# INFORMATION BULLETIN

NAT Part #: **CC450-0V2**

Description: **Communications Controller**

Document #: **CC450\0V2\609-0001**

Side view of CC450-0V2

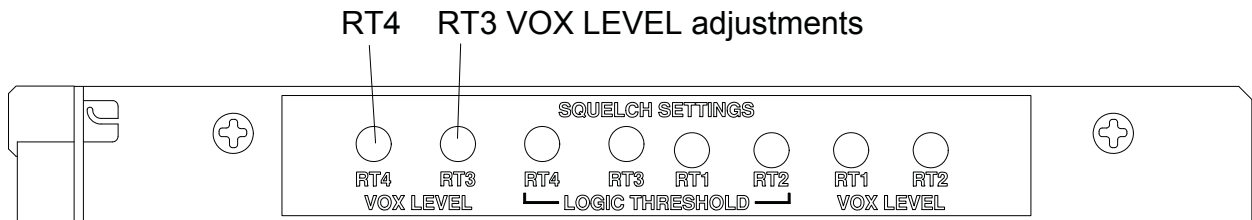
### 2.1 Adjustments of RT3 and RT4 VOX LEVELS.

The RT3 and RT4 VOX LEVEL adjustments on the side of this unit are adjusted as follows:

Most Sensitive: Rotate fully clockwise.

Least Sensitive: Rotate fully counterclockwise.

Note. The rotation of these adjustments is opposite to the RT2 and RT1 VOX LEVEL adjustments.
